Pearl Place 2

Project # MSHA-RLP-1522

Addendum No. 3 to Contract Documents

August 25, 2011

SHEET
SKA-1

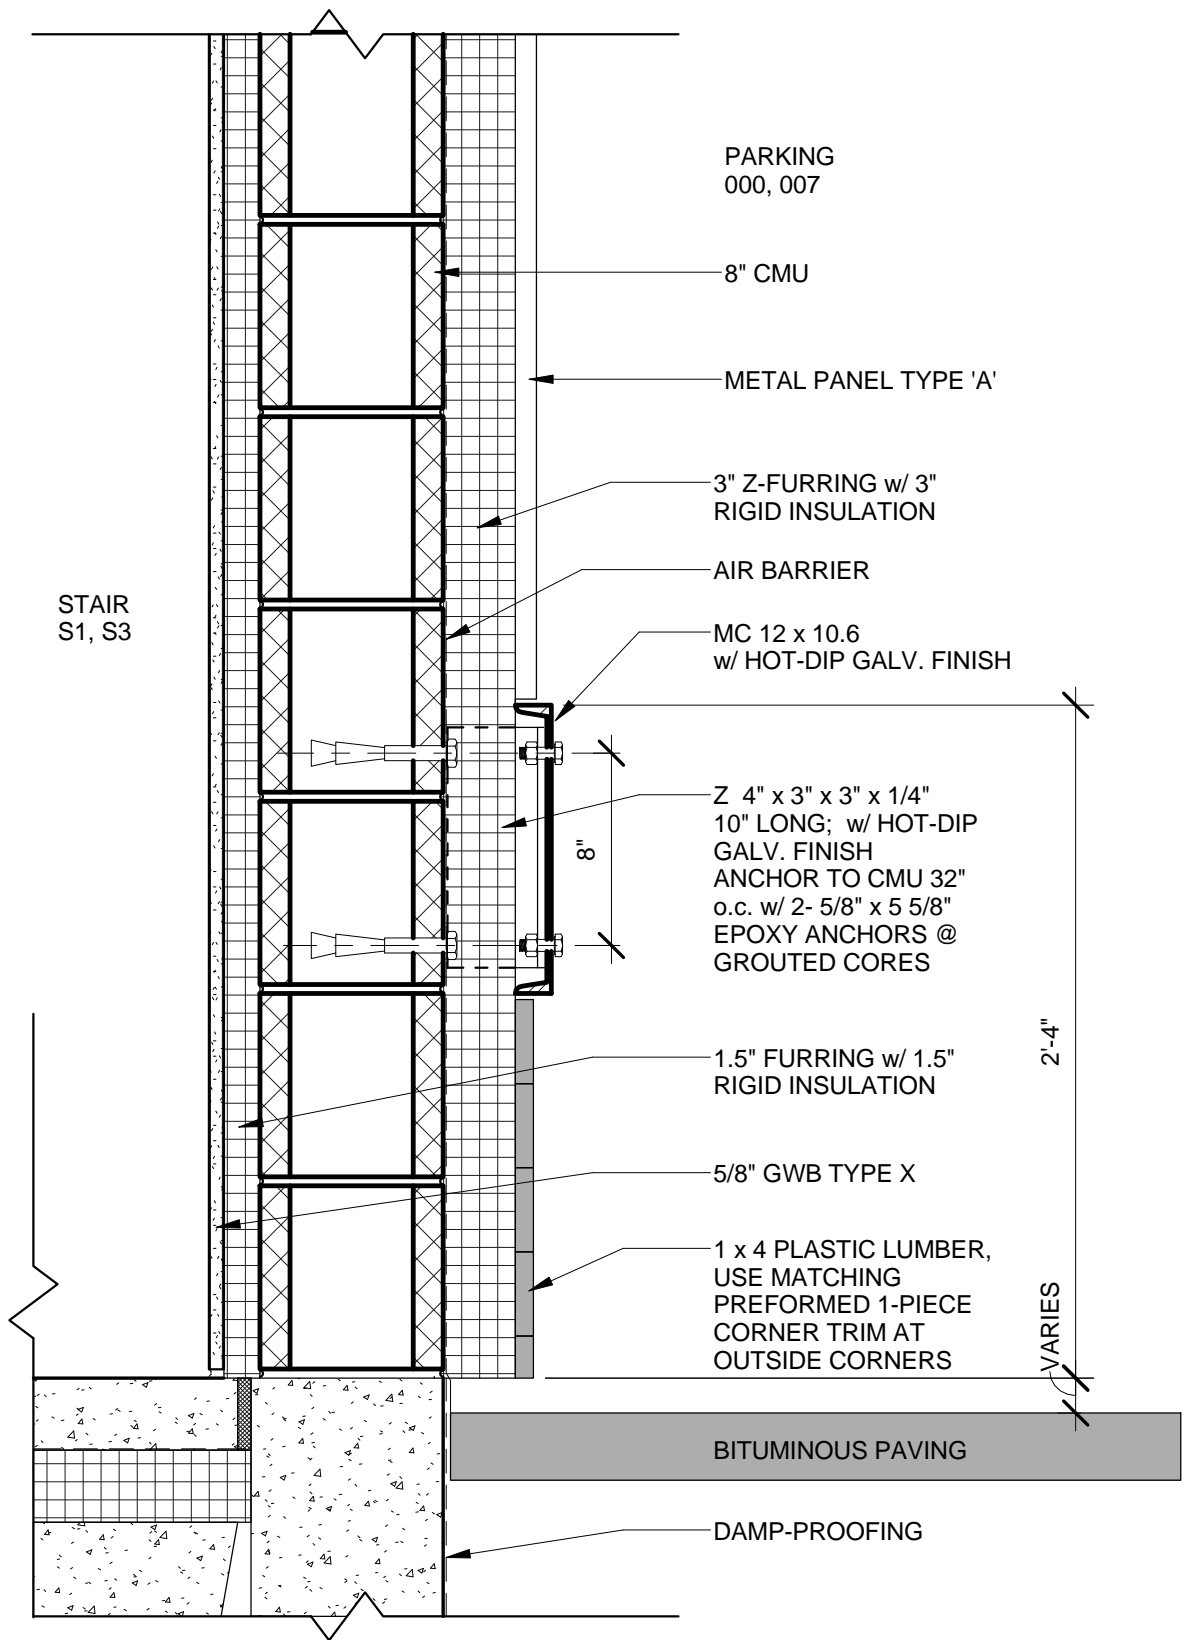
- K. Drawing A601, “DOOR AND FRAME SCHEDULE”, ADD: DOOR 408K.1. This door’s parameters shall match door 308M.1
- L. Sketch SKA-1 for Ground floor Plan at Stairs1 & 3: revised wall type is hereby attached

TITLE
Revised Wall Type @ Stairs
1 & 3, Ground Level

SHEET
SKA-2

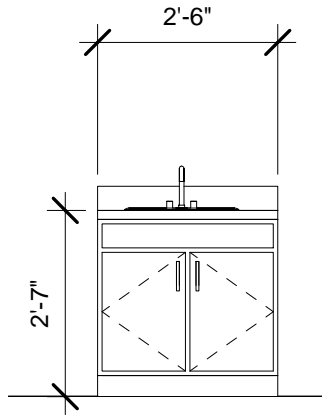
- M. Sketch SKA-2 for wall section detail of Stairs 1 & 3 at Ground Floor is hereby attached
- N. Sketch SKA-3 for interior elevations at bathroom vanities

TITLE
**TYPICAL PARTIAL WALL
SECTION @ STAIRS 1 & 3**

SKS-2

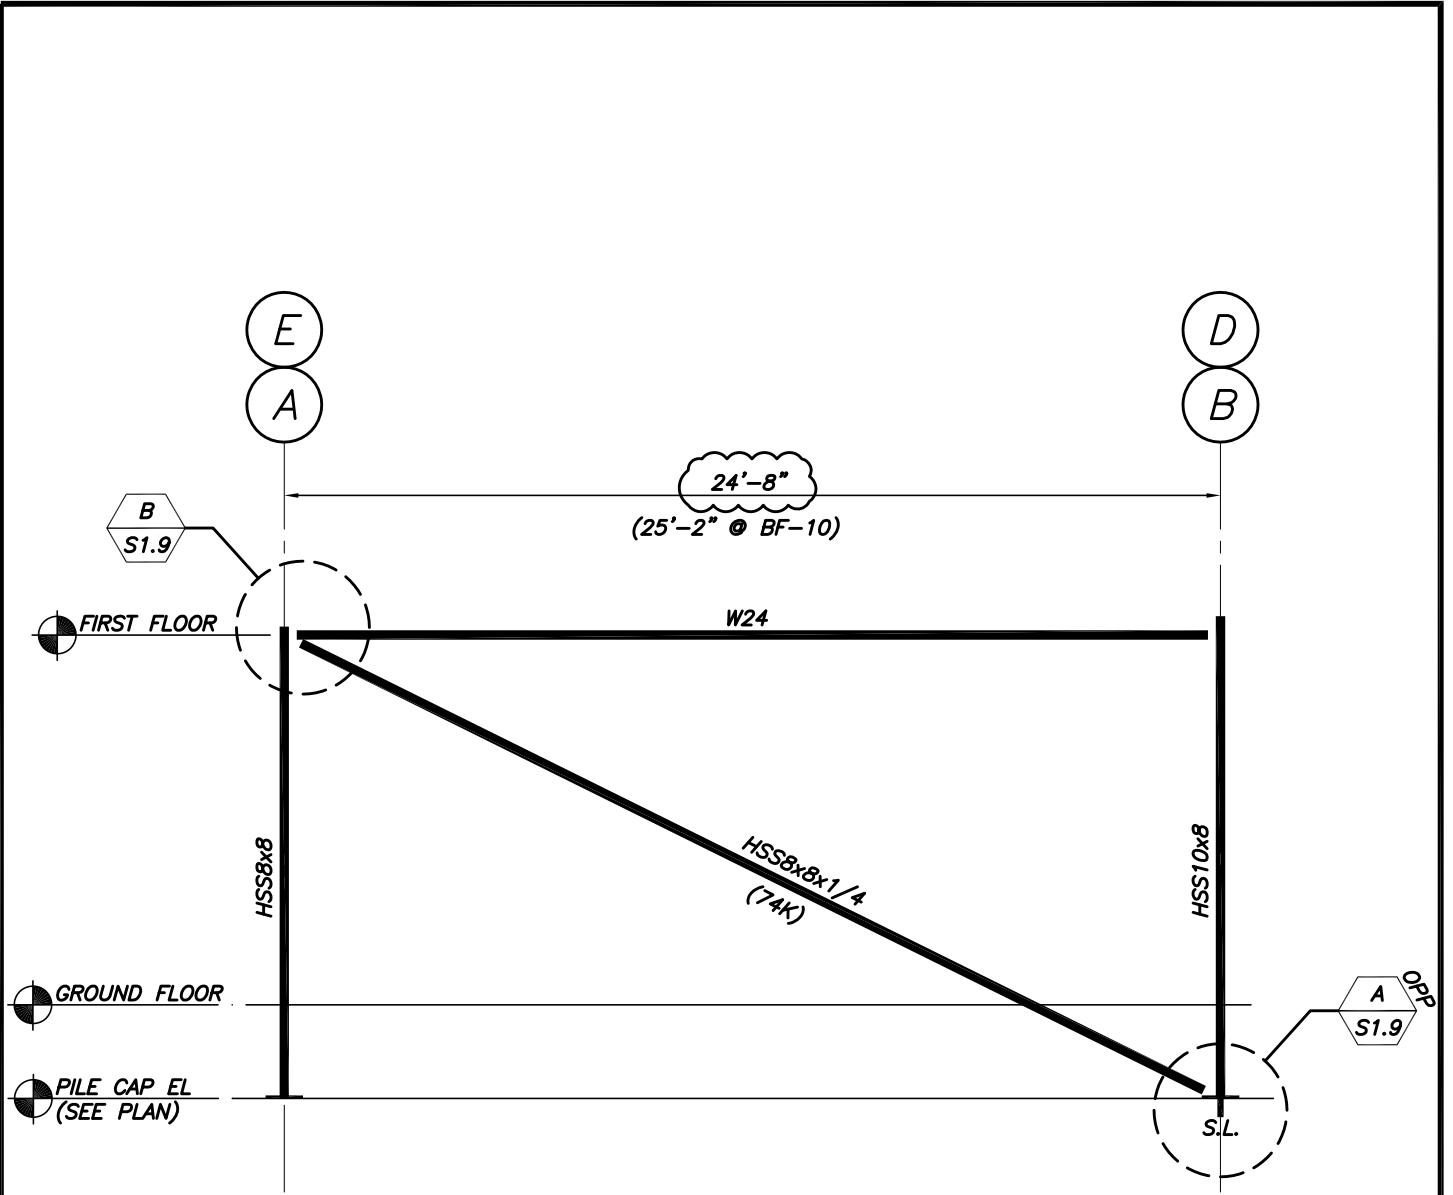
- A. Drawings S1.4 and S1.5: DELETE all notes for “P4” posts
- B. Sketch SKS-1 Revision 1 is hereby attached
- C. Sketches SKS-2, SKS-2, SKS-3, SKS-4, and SKS-5 are hereby attached to document relocation of column line B.

PEARL PLACE II
PORTLAND, ME
REV. SECT 3/S3.2
